STATE OF NORTH CAROLINA
DEPARTMENT OF TRANSPORTATION

May 7, 2014

Subject: **Permit Modification Request for Section 404 Nationwide 23, Section 401 Water Quality Certification and Tar-Pamlico Buffer Authorization** for the construction of a new rest area along US 17 near Chocowinity in Beaufort County; TIP Project K-3800; Federal Project No. NHS-17(32); WBS No. 38748.1.1.

References: Permit application dated 6/19/2013, Permit modification request dated 3/13/14
404 issued 11/13/13, Action Id. SAW-2013-02202
401 issued 8/9/13, DWR Project No. 20130649.

PROJECT REFERENCE NO. K-3800	SHEET NO. 4
RW SHEET NO.	
ROADWAY DESIGN ENGINEER	HYDRAULICS ENGINEER
Permit Drawing	
Sheet 2 of 10	
Revised 4/14/14

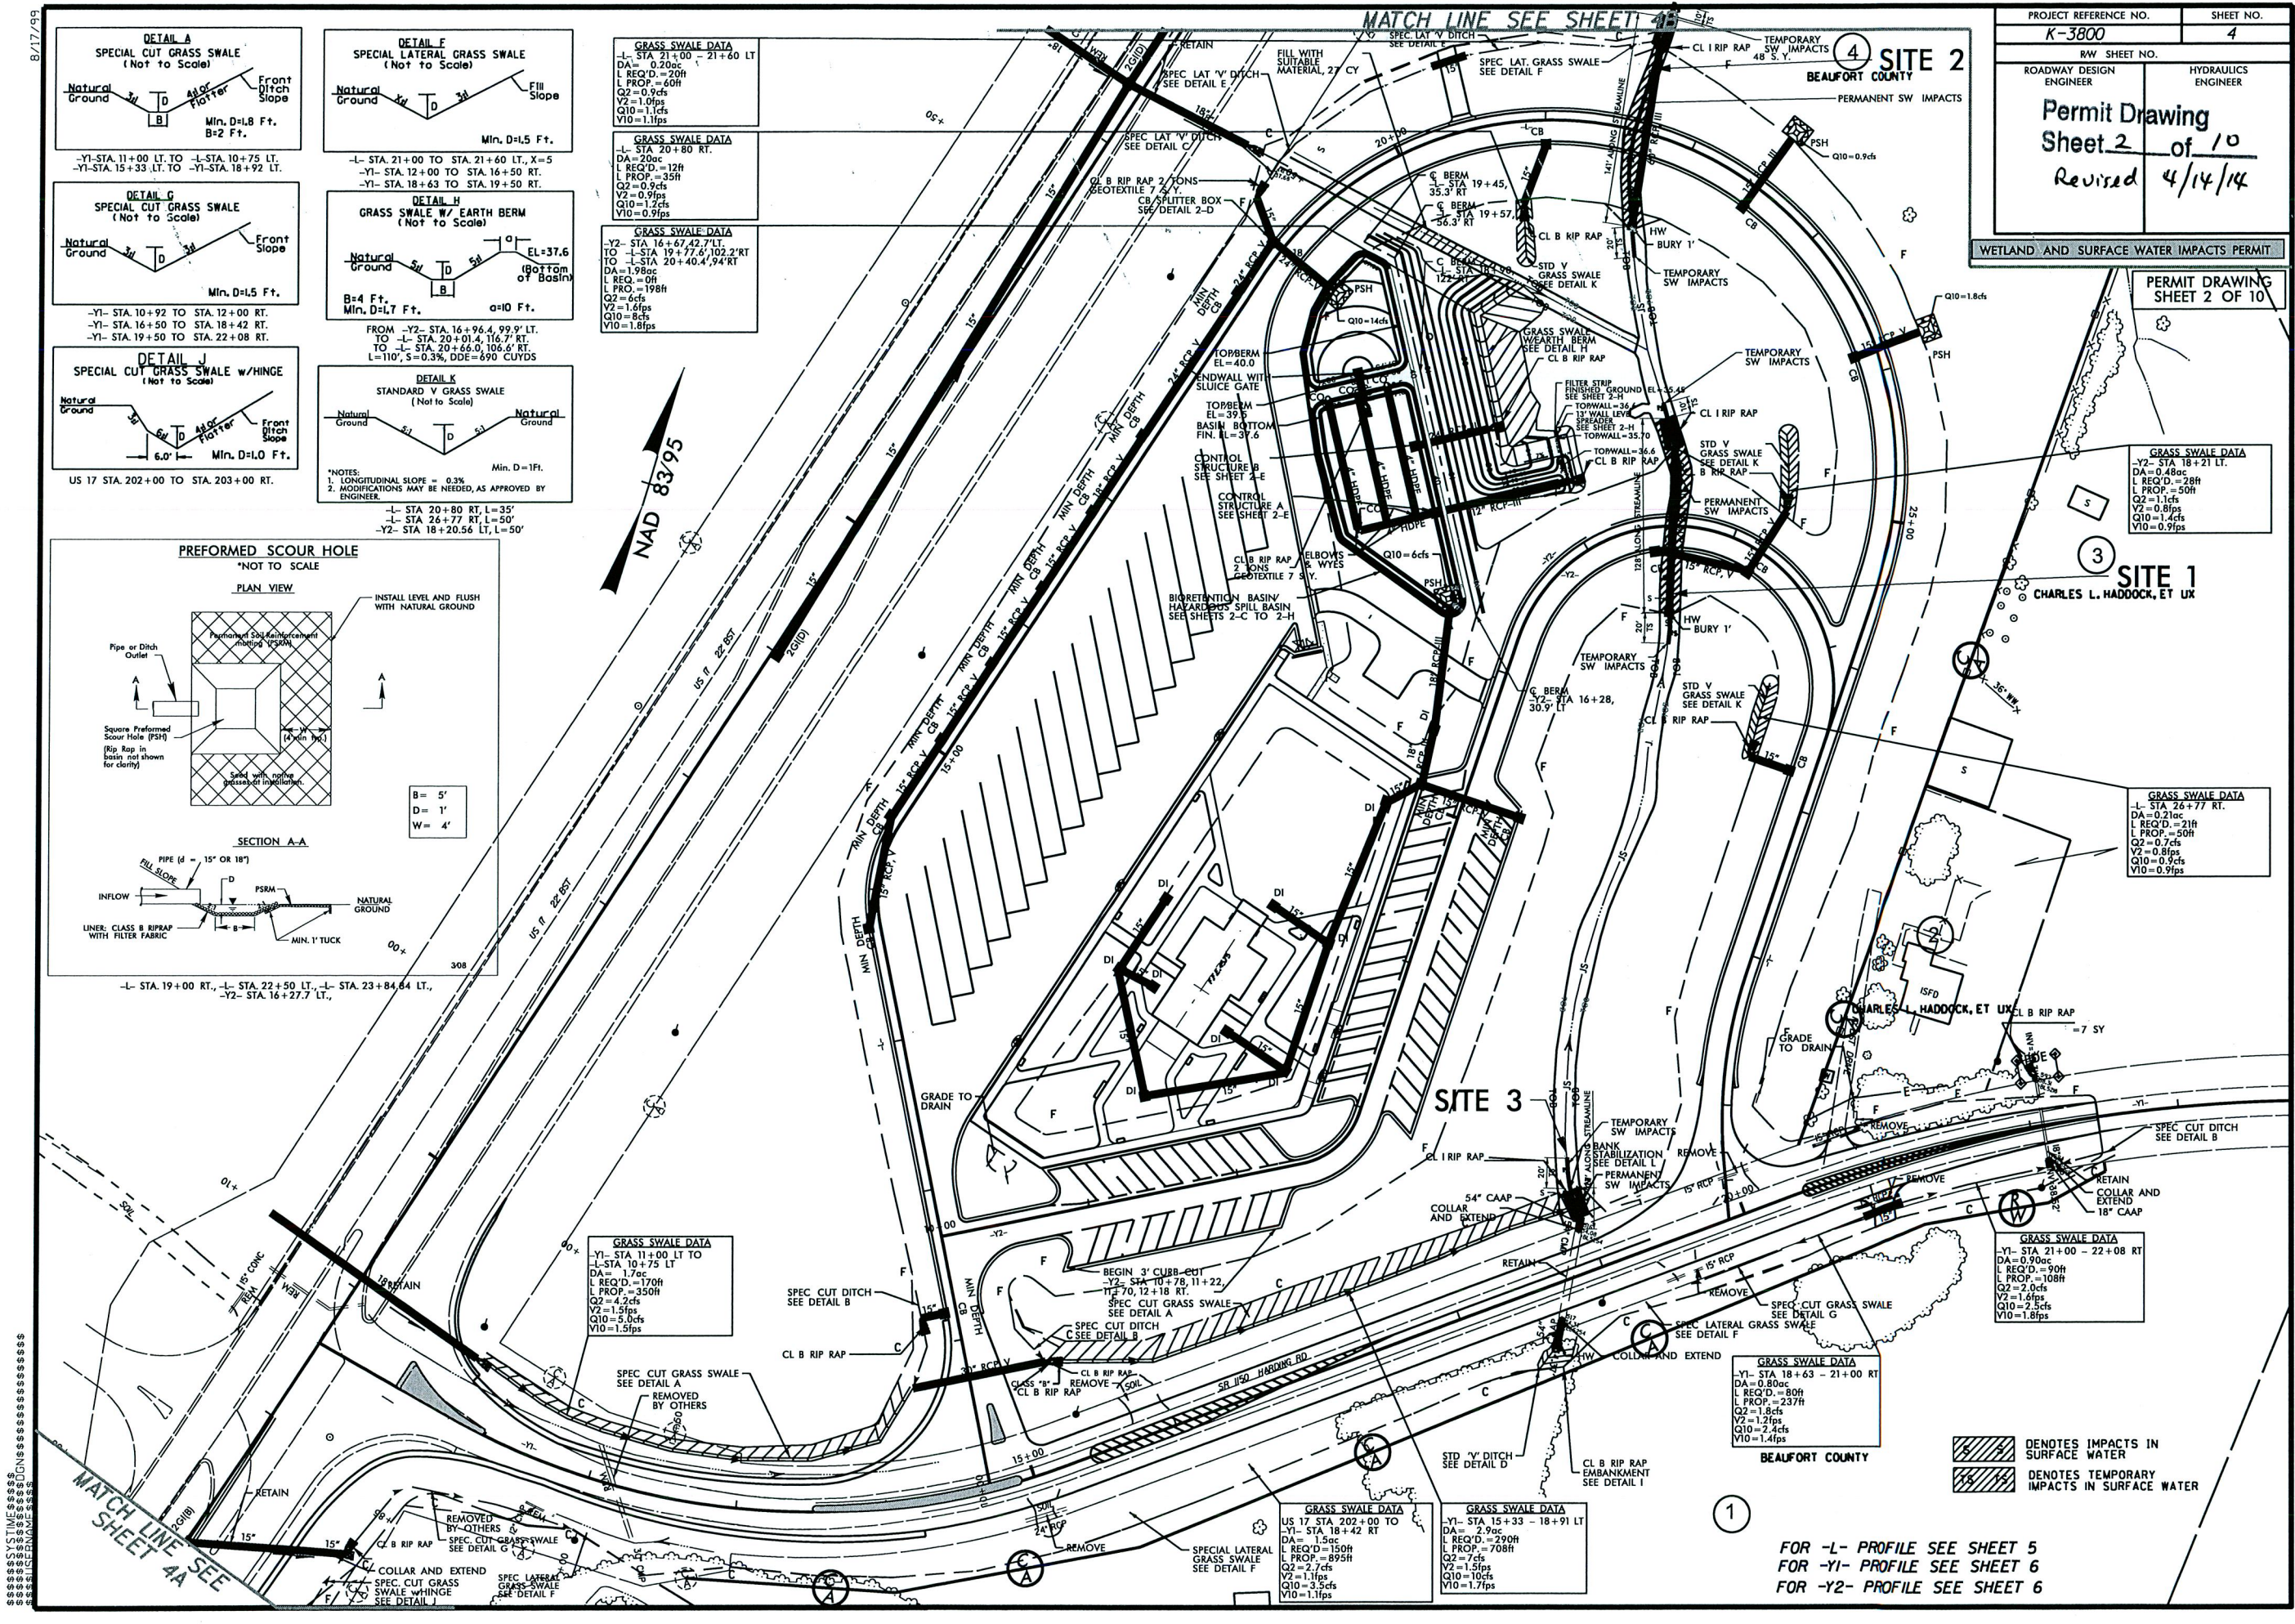
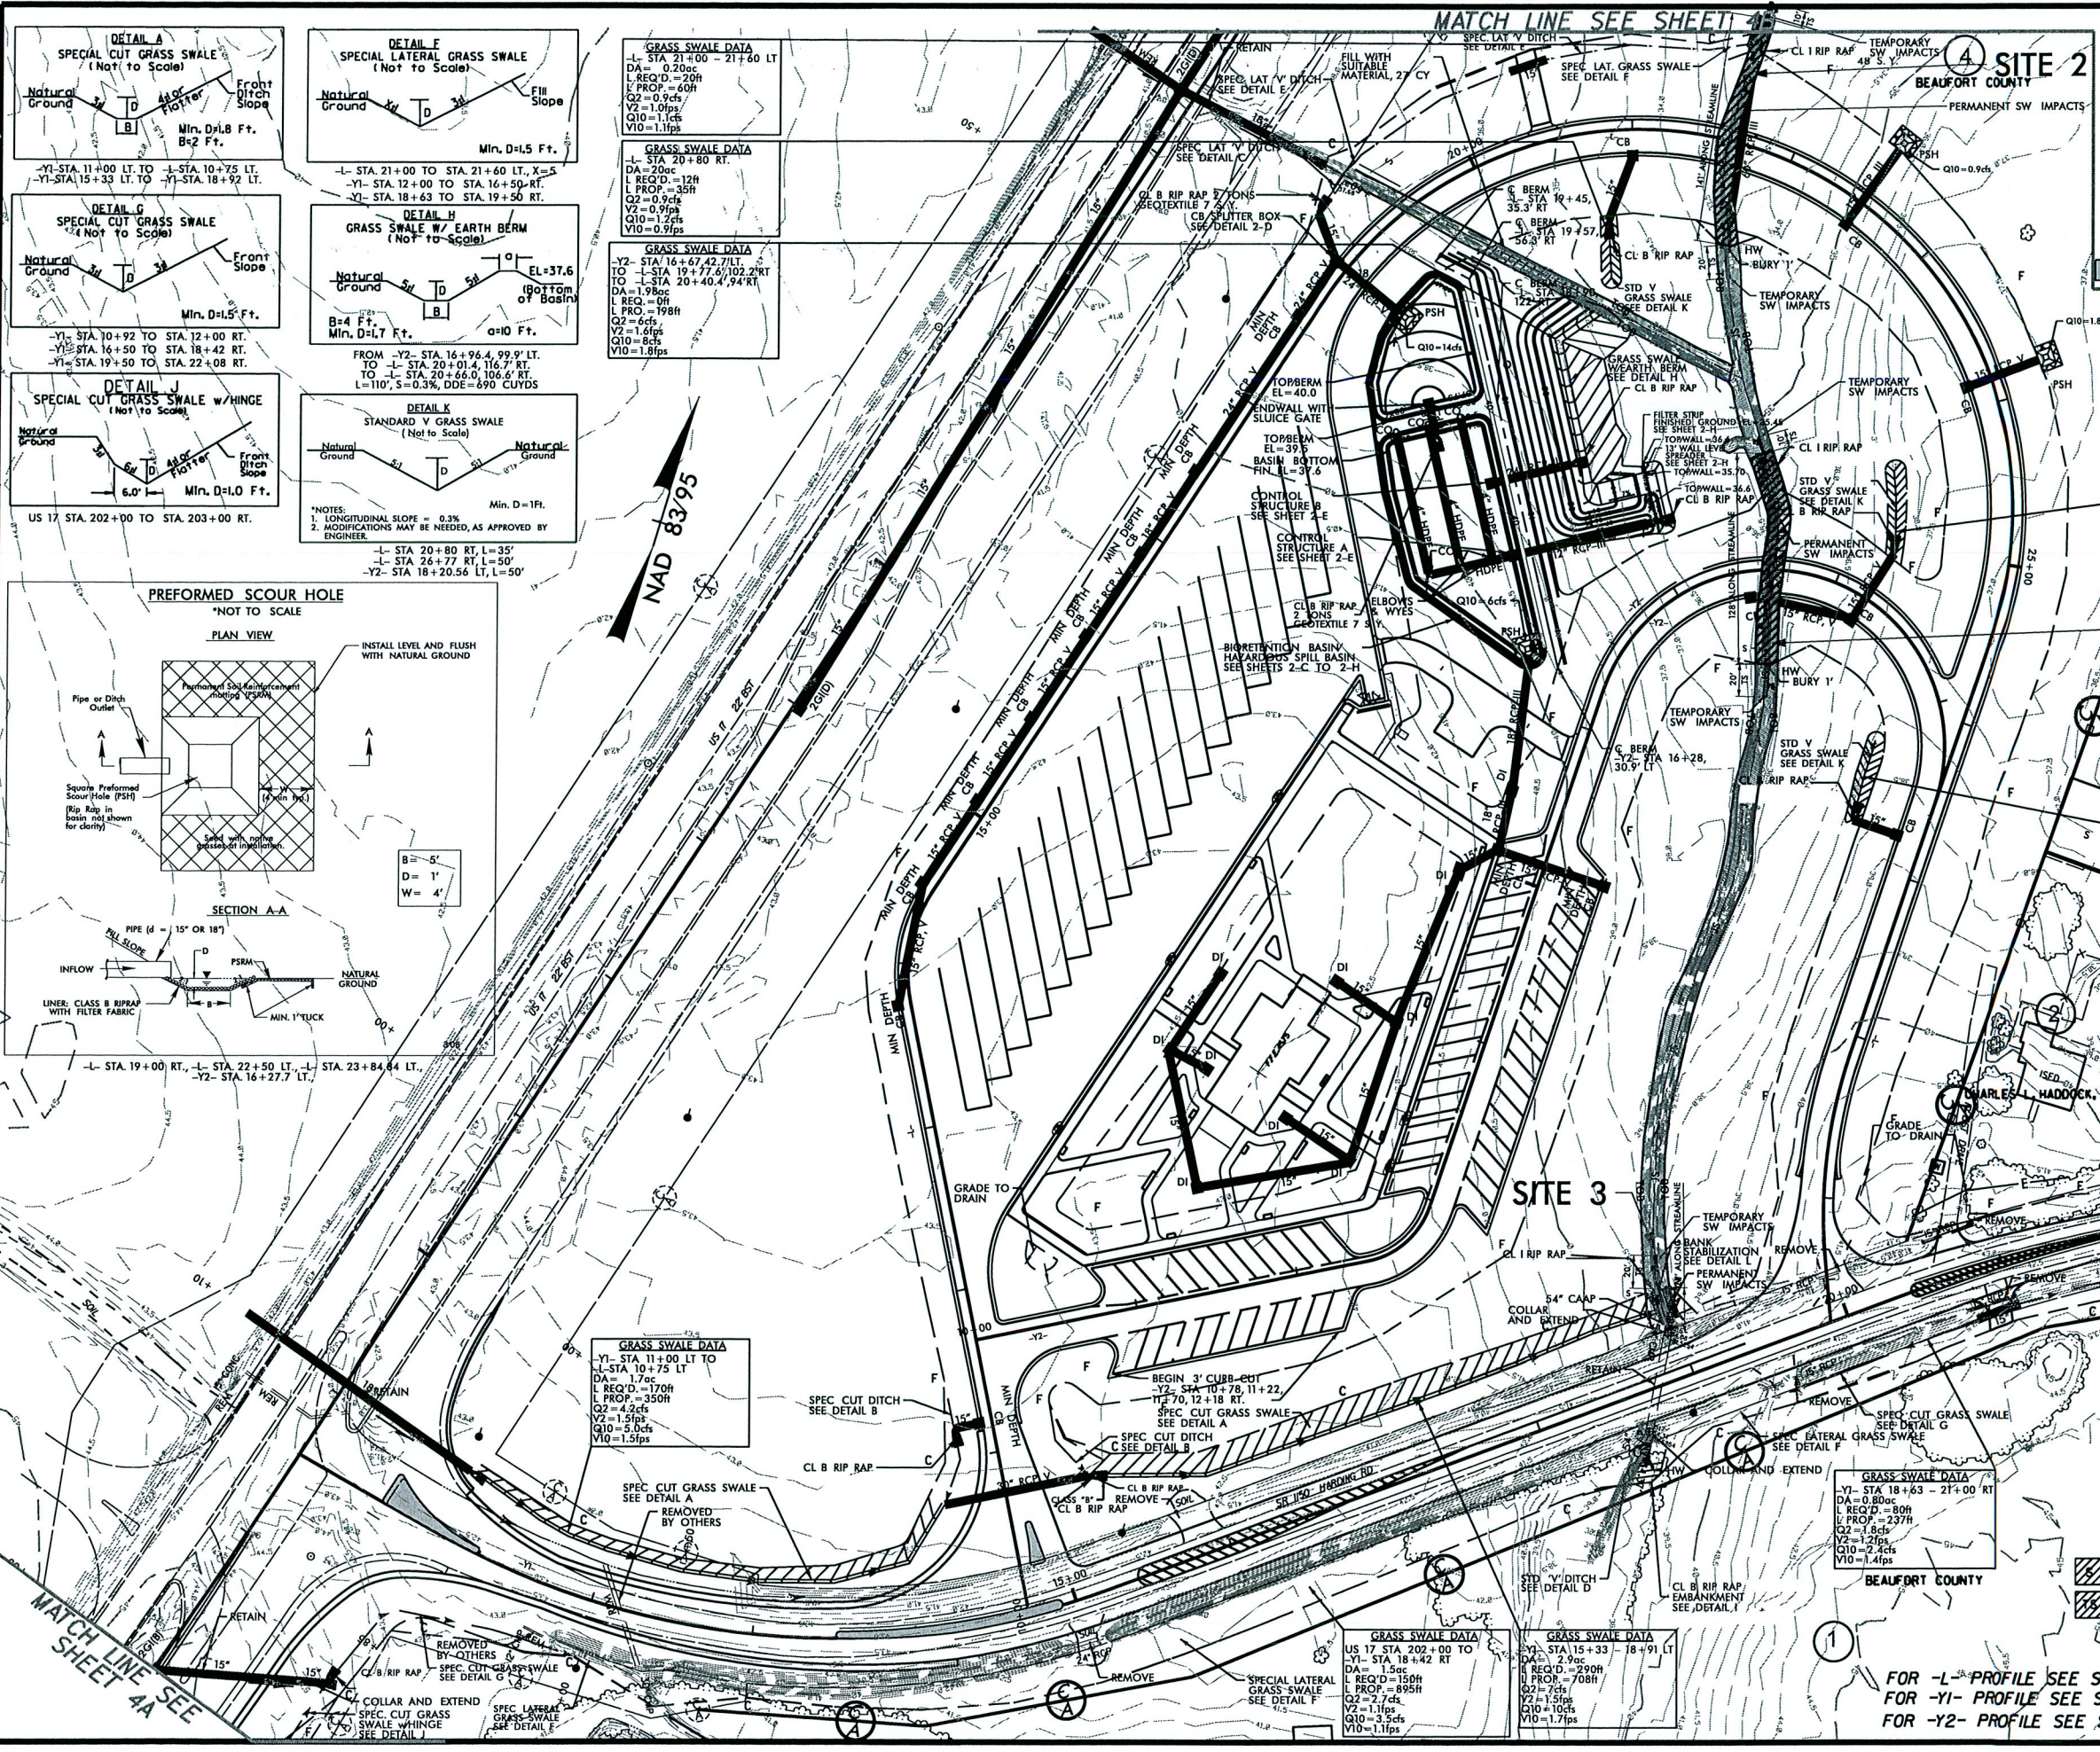
As a result of the stream’s jurisdictional starting point now at the pipe outfall, additional stream impacts (Site 3) and buffer impacts (Site 4) are now proposed. Buffer Site 4 will have impacts to buffers in both Zone 1 and Zone 2:

This increases the overall project buffer impacts to a total of 12,935 sq. ft. in Zone 1 and 9,291 sq. ft. in Zone 2, totaling 22,226 sq. ft. of buffer impacts for the project. Permanent stream impacts have also increased by 27 ft now totaling 296 ft. Revised permit drawings are included with this modification request.

PROJECT REFERENCE NO. K-3800	SHEET NO. 4
RW SHEET NO.	HYDRAULICS ENGINEER
ROADWAY DESIGN ENGINEER	HYDRAULICS ENGINEER
Buffer Drawing	
Sheet 3 of 10	
Revised 4/14/14

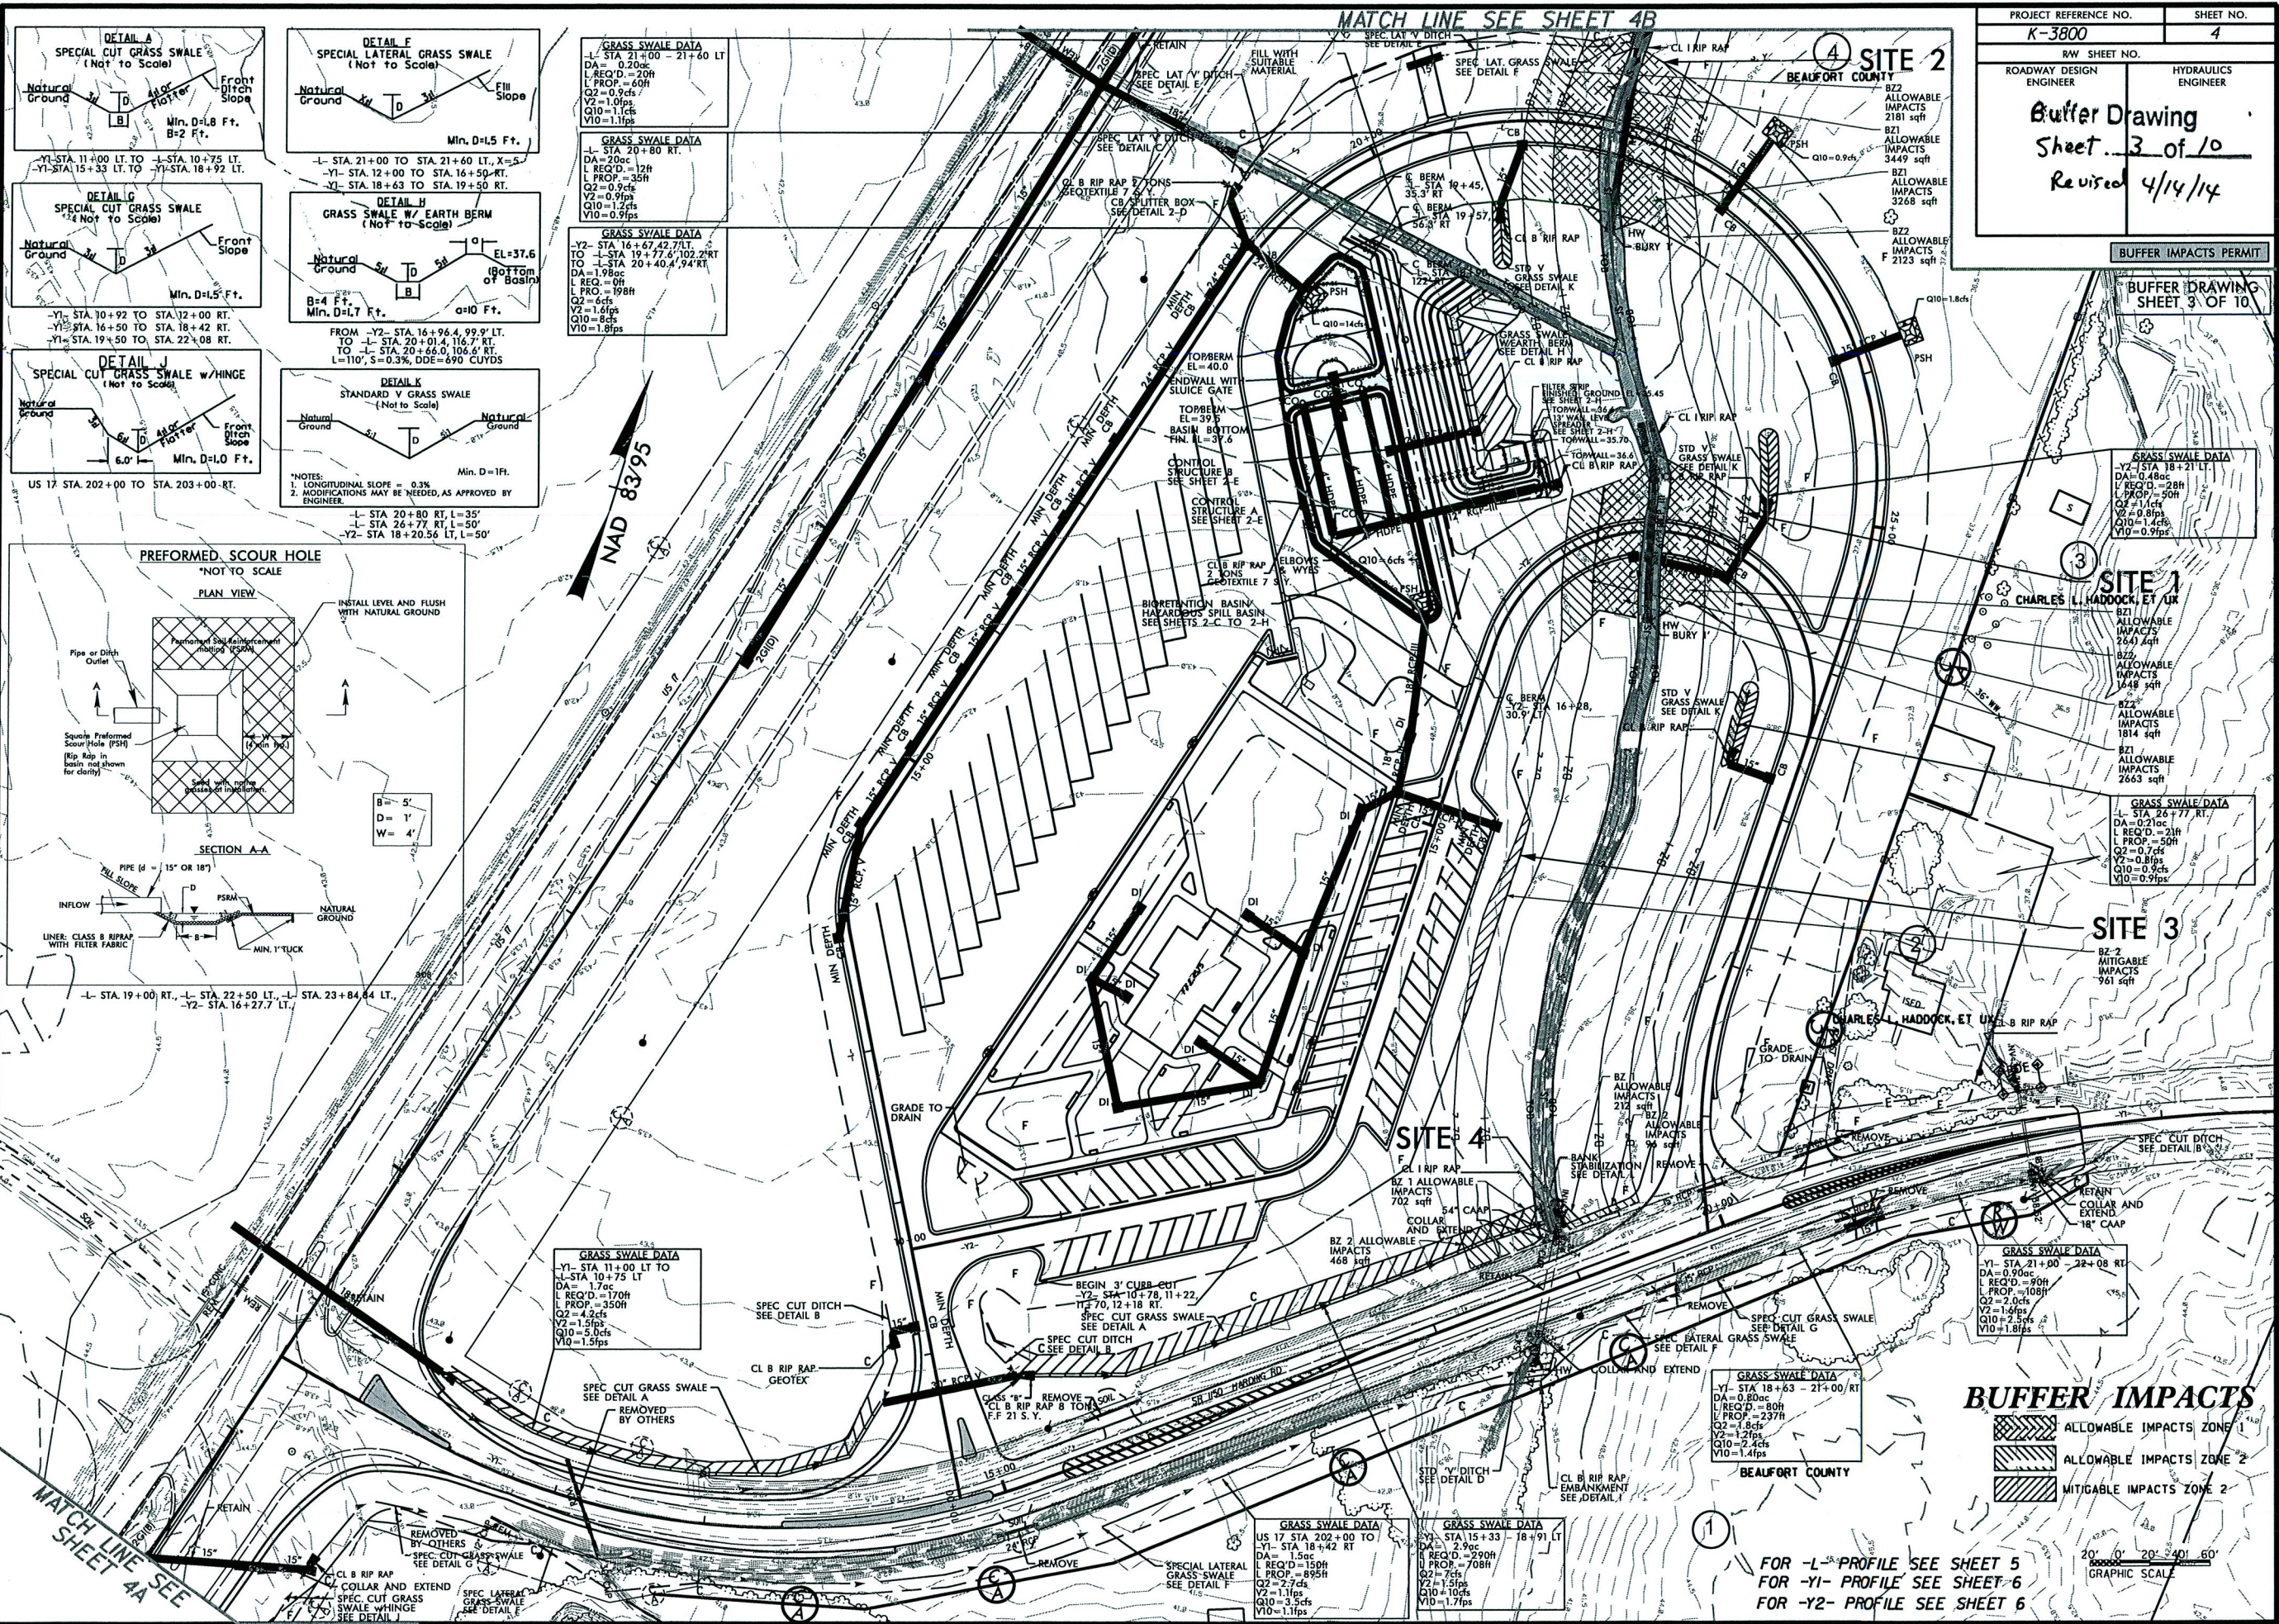
Site	Zone 1 (sq. ft.)	Zone 2 (sq. ft.)	Total (sq. ft.)
Buffer Drawing Site 4	914	564	1,478
